# **Adaptation to Scientific and Technical Progress under Directive 2002/95/EC**

**Contract N°  
07010401/2006/445990/ATA/G4**

**Final Report  
- Final -**

**Freiburg, 22 October 2007**

Figure 6: Physical appearance and homogeneous materials in Macron photoresistors (source: RWTT test report, document no. 12 in references in section 5.3.6)

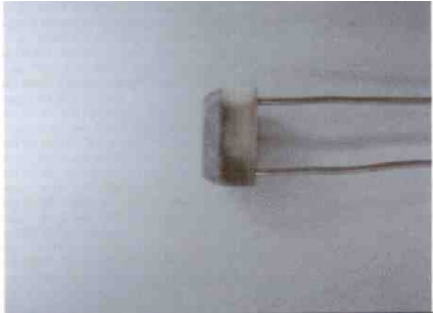
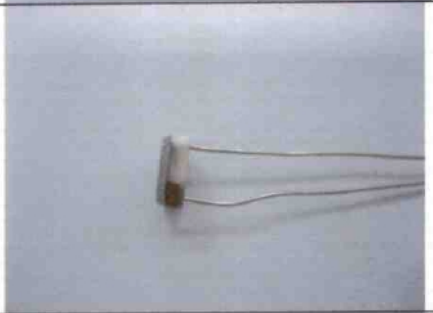
ERA challenges the homogeneous material definition of the RWTT test reports. ERA says that the “white ceramic” (sample 1 in the Macron test report) can be mechanically disjointed into two homogeneous materials:

Figure 15: Physical appearance and homogeneous materials in Macron photoresistors (source: RWTT test report, document no. 12 in references in section 5.3.6)

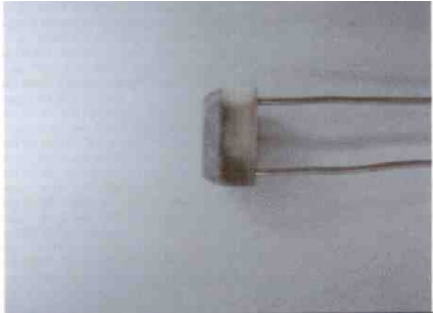
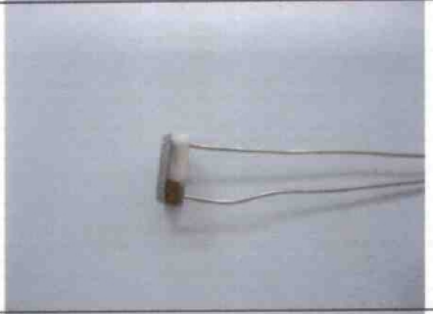
"White ceramic" is also used in other sections of the test report, e.g. in the following figure as well as in the description of the samplings and the analyses in Table 8 in section 5.3.4.1.

This denomination is consistent throughout the test report no. 12 in section 5.3.6. The testing laboratory considers the white ceramic part as homogeneous material, as the following figure underpins.
